### **AMENDMENTS TO THE DRAWINGS**

## REMARKS

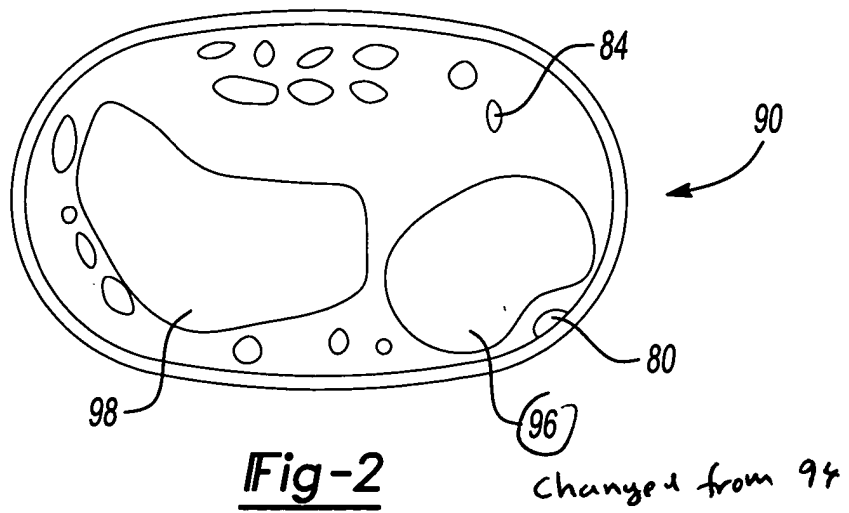
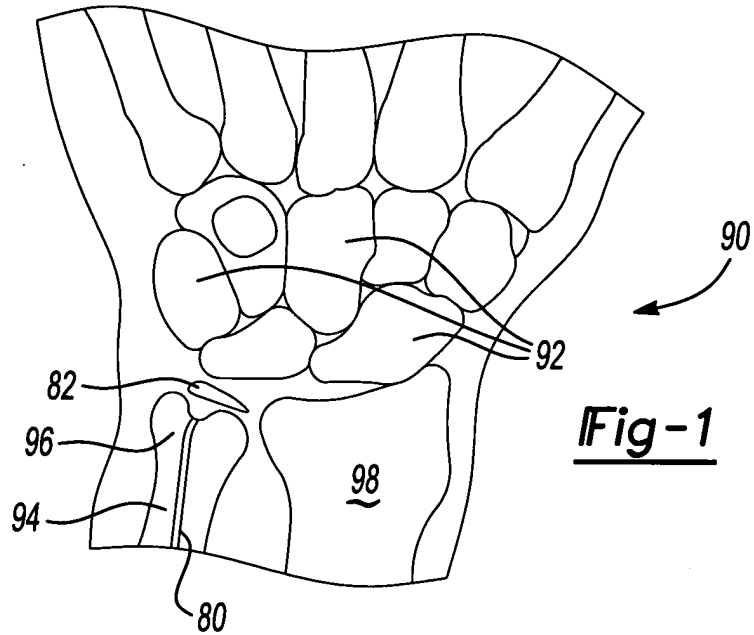
The Replacement Sheets 1 and 3 also include revised Figures 2, 5B and 5C for the Examiner's approval. In each of Figures 2, 5B and 5C, the reference numeral pointing to the ulnar styloid was changed from 94 to 96 to correct an inadvertent typographical error in the Figures. The ulnar styloid is consistently associated in the specification with the reference numeral 96. No new matter has been introduced by this change.
